THE CITY OF WICHITA

Re: Central & Ridge Community Unit Plan DP-39
Major Shopping Center Approaches

Subject: West Branch YMCA Site
(Central Ridge Addition)

**SUBJECT Central Ridge Addition -
West Branch YMCA**

Central Ridge

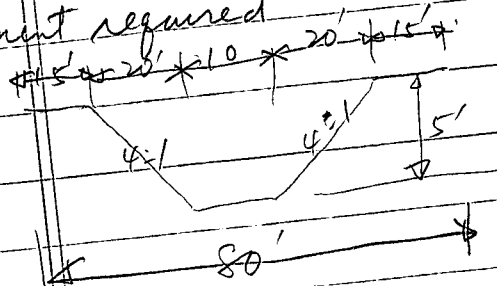
1. Need information on run off quantity
FE of channel, outlet structure &
FE elevation before final plat can
be approved. Also, submit calculation

to show the existing ditch has sufficient
capacity to carry the depress runoff
due to the development of this plat.

2. Area = 26 Ac Assume $C = .7$ $I_{100} = 8.98$

$$Q_{100} = 26 \times .7 \times 8.98 = 163 \text{ cfs}$$

* Channel capacity (assume water depth = 4',
slope = 0.1%) = 294 cfs

Easement required

85' easement O.K
